SCHWEIZER SERVICE NOTICE

NOTICE NO. N-194
DATE 1/9/85
PAGE 1 OF 5

SUBJECT: ONE-TIME INSPECTION AND REWORK OF 269A4262 INERTIA REEL SHOULDER HARNESS ASSEMBLIES AND INSTALLATION.

MODELS AFFECTED: All 269A, TH-55A, 269A-1, 269B and 269C Series helicopters equipped with 269A4262 inertia reel shoulder harness assemblies and all harness assemblies in spares inventory at date of this notice.

FIGURE 1
INSTALLATION CONFIGURATION FOR HARNESS
ASSEMBLIES WHICH WRAP OVER THE TOP OF
INERTIA REEL ASSEMBLY

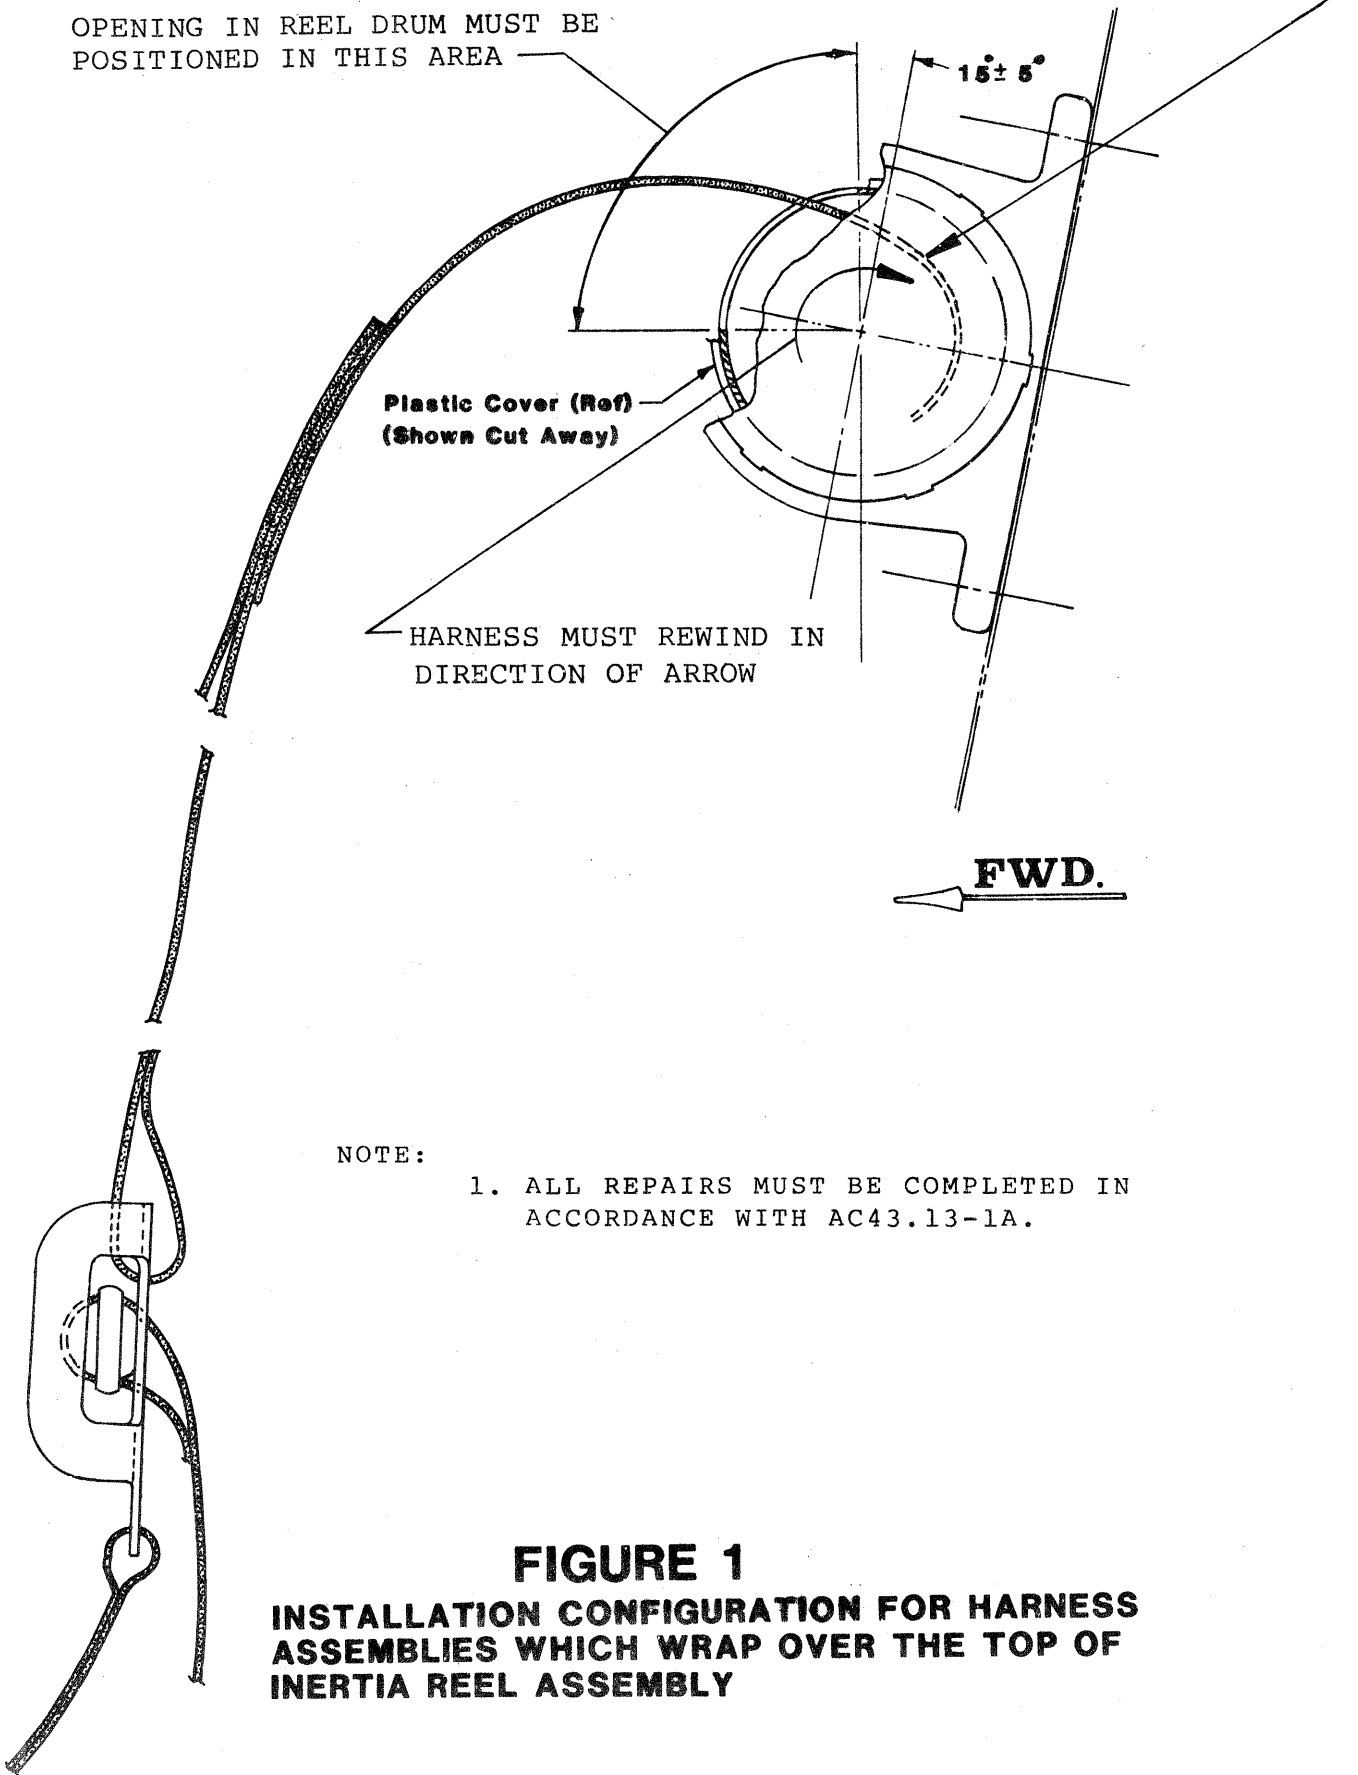
1. The reel may be installed with the harness strap coming off the top or bottom of the reel, whichever will allow correct positioning of the harness on the wearer.
2. With the harness strap coming off the top of the inertia reel the slotted opening in the metal reel housing is to be positioned facing forward with the top of the opening at an angle of $15^{\circ} \pm 5^{\circ}$ relative to the 269A2103 panel. See figure 1.

OPENING IN REEL DRUM MUST BE
POSITIONED IN THIS AREA

HARNESS MUST REWIND
OVER TOP OF DRUM

HARNESS MUST REWIND IN
DIRECTION OF ARROW

1. If harness assembly cannot be properly positioned on user, i.e. tensioning buckles press against users chest, reverse inertia reel installation so strap comes off the top or bottom, (whichever is opposite the installed reel).
2. To position the slotted opening correctly, remove mounting feet from reel assembly and reindex to proper position.

NOTE: The mounting feet simply pull off from the end of the inertia reel assembly and can be indexed at 60° increments.

FIGURE 2
INSTALLATION CONFIGURATION FOR HARNESS ASSEMBLIES WHICH WRAP UNDER THE BOTTOM OF INERTIA REEL ASSEMBLY

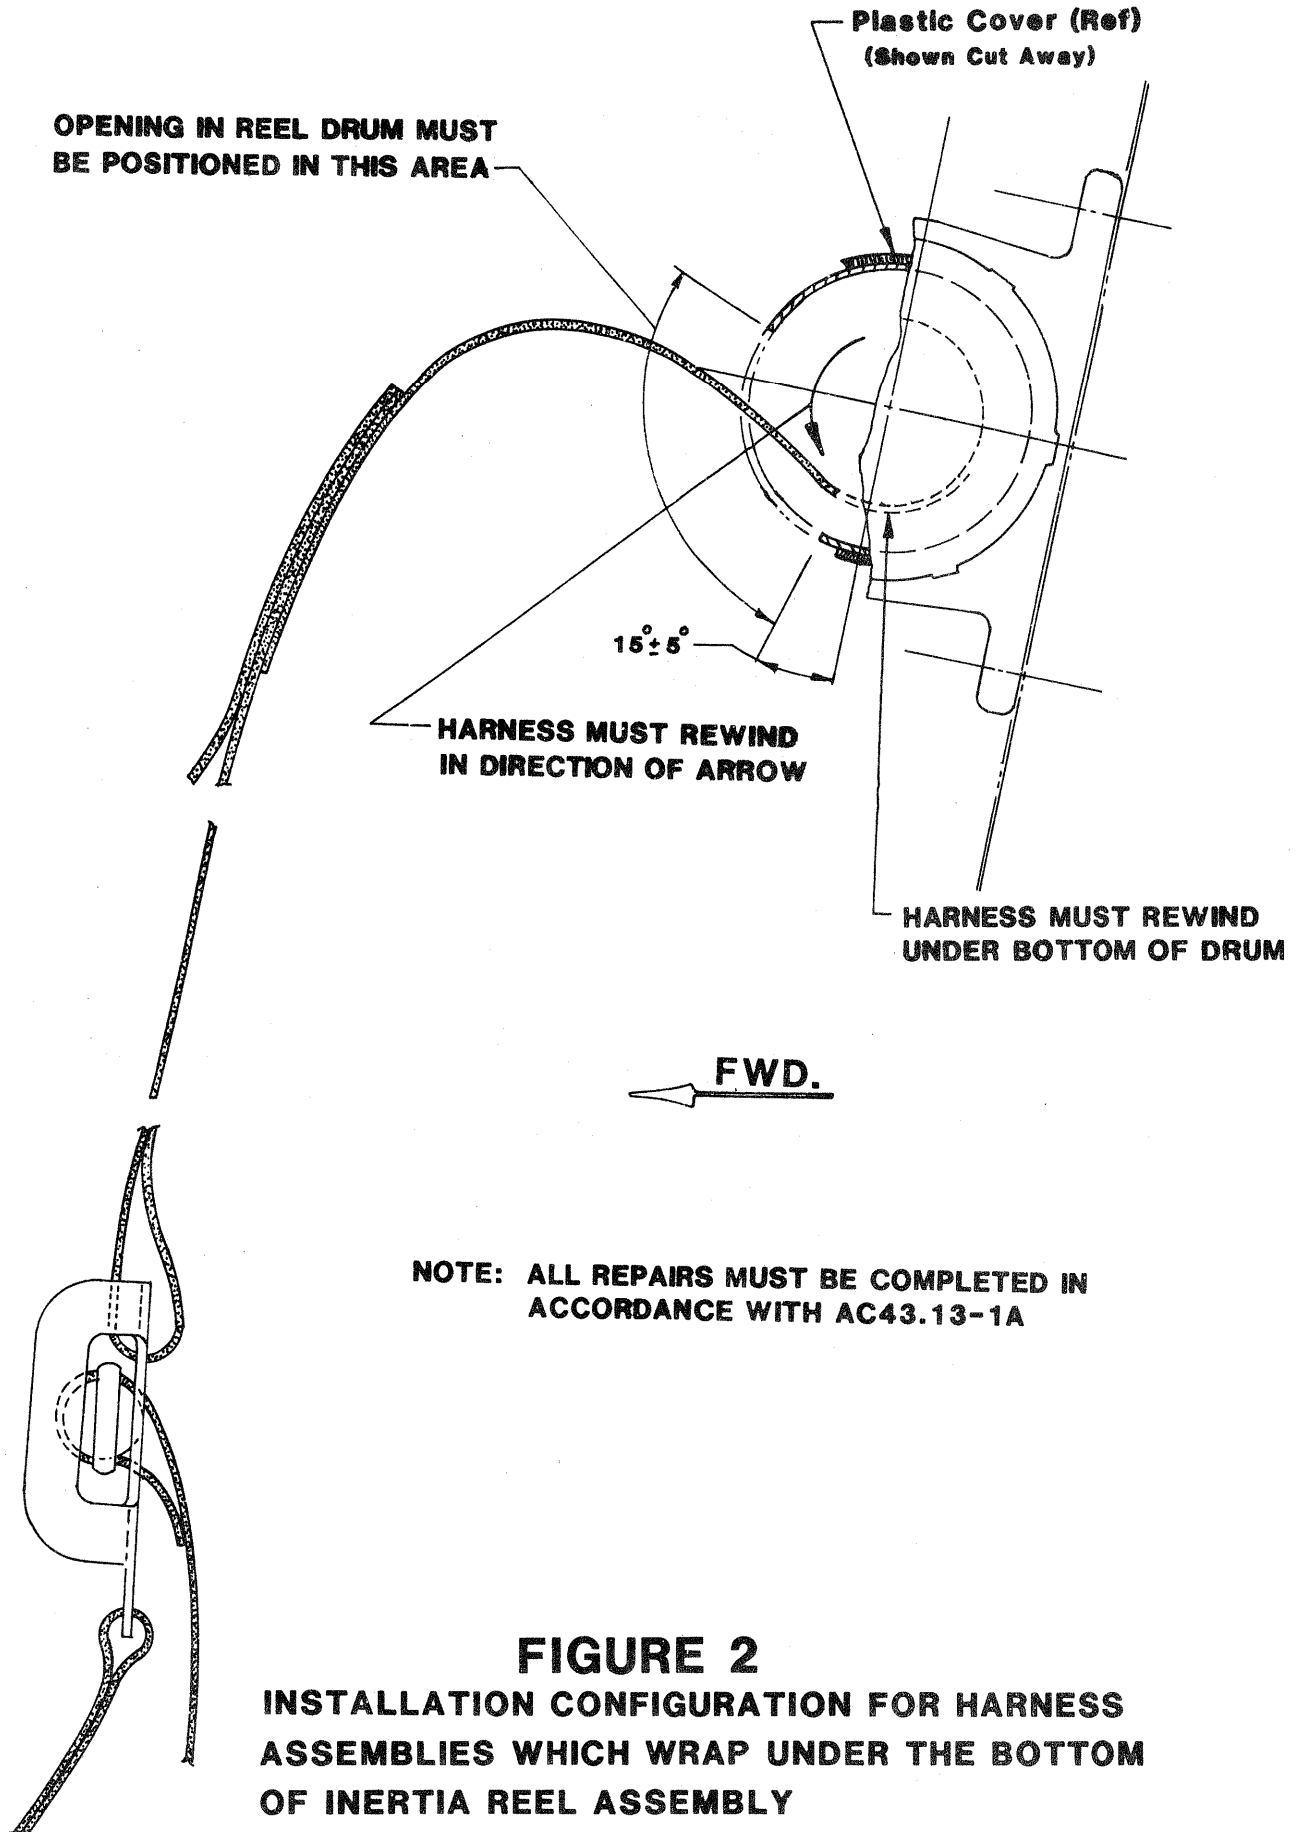
With the harness strap coming off the bottom of the inertia reel, the slotted opening in the metal reel housing is to be positioned facing forward with the bottom at the opening at an angle of $15^{\circ} \pm 5^{\circ}$ relative to the 269A2103 panel. See figure 2.
